**Detailed Site Plan**  
**Departure from Parking and Loading Standards**  
**Departure from Design Standards**  
**Alternative Compliance**  
**Oxon Hill McDonald's**

**DSP-18051**  
**DPLS-463**  
**DDS-658**  
**AC-19005**

STAFF REPORT

SUBJECT: Detailed Site Plan DSP-18051  
Departure from Parking and Loading Standards DPLS-463  
Departure from Design Standards DDS-658  
Alternative Compliance AC-19005  
Oxon Hill McDonald's

# DETAILS SHEET

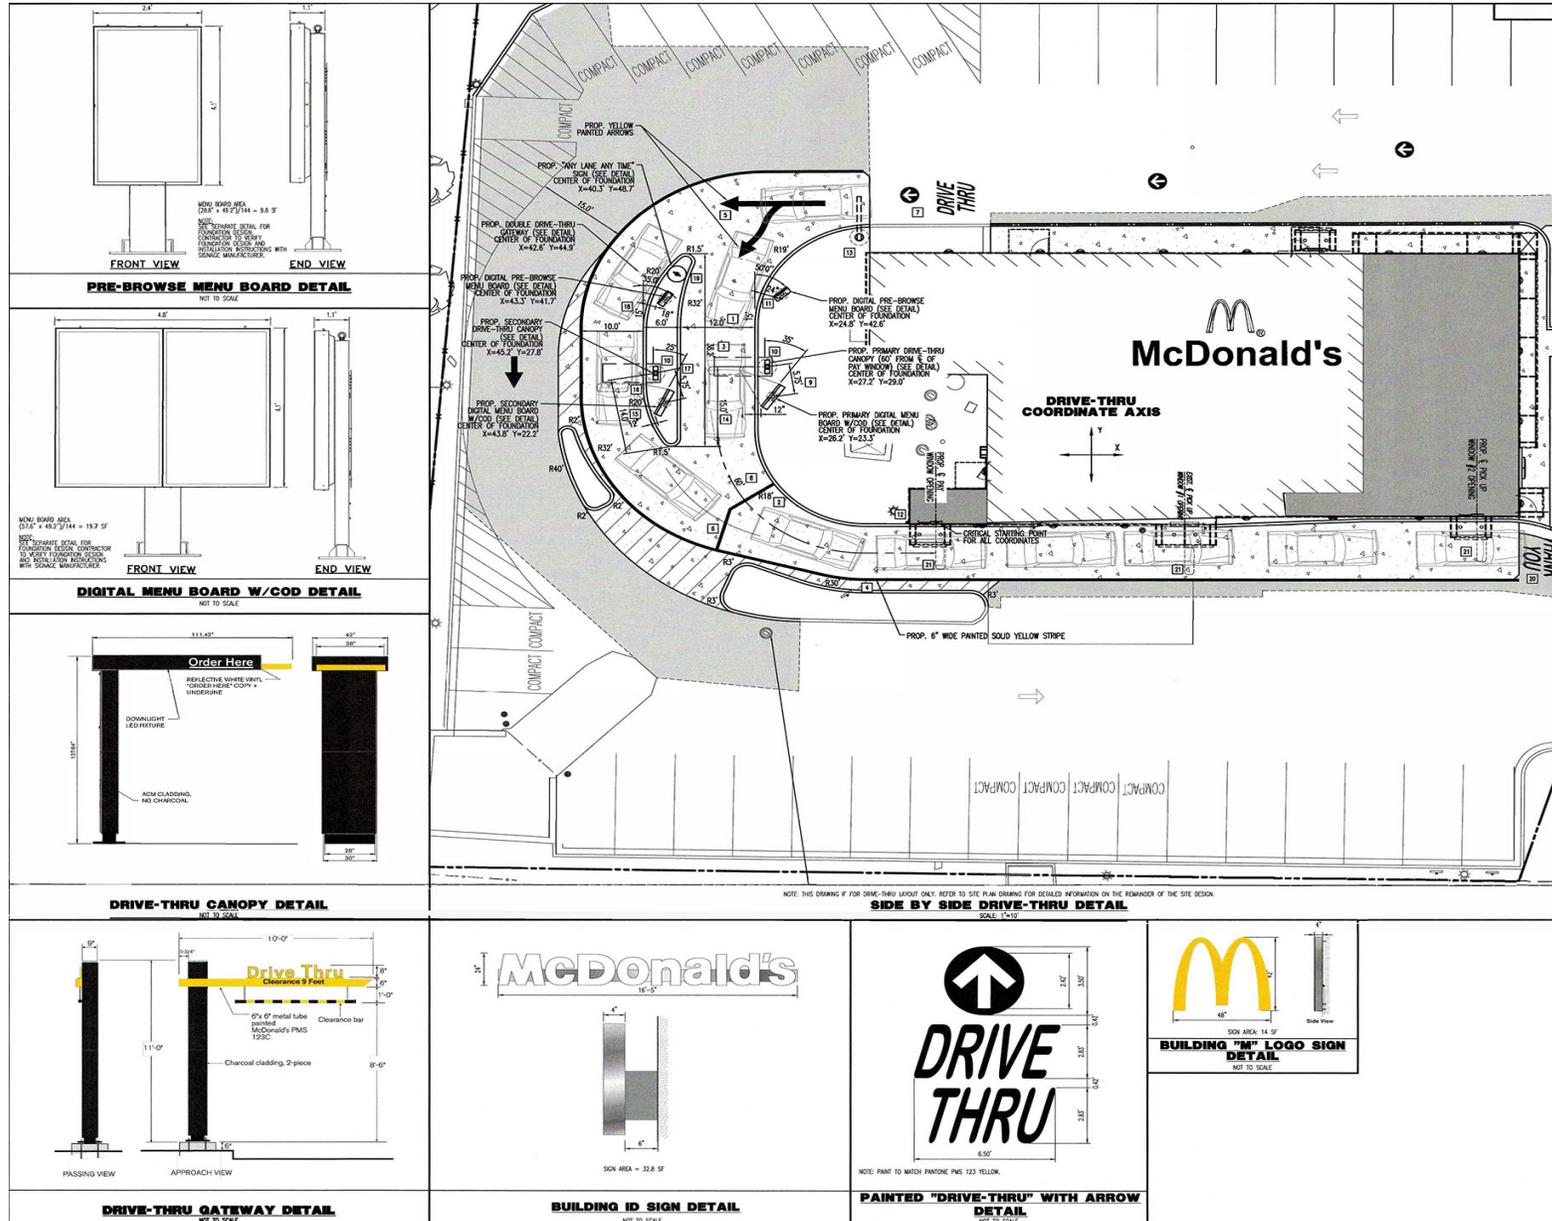
8. Sheet C 10 shows the side-by-side drive through detail. This representation of how the traffic flows into the drive through lanes should also be depicted on the Site Plan. Furthermore, the site plan does not show the drive isle width between the entrance off Oxon Hill Road and the

- c. Add a trash enclosure detail to the plan, which shall be constructed of a durable, quality material to match the building.
    - d. Indicate traffic flow into the drive-through lanes, as well as a minimum width of the drive aisles of 11 feet between the marking line and the adjacent parking spaces.
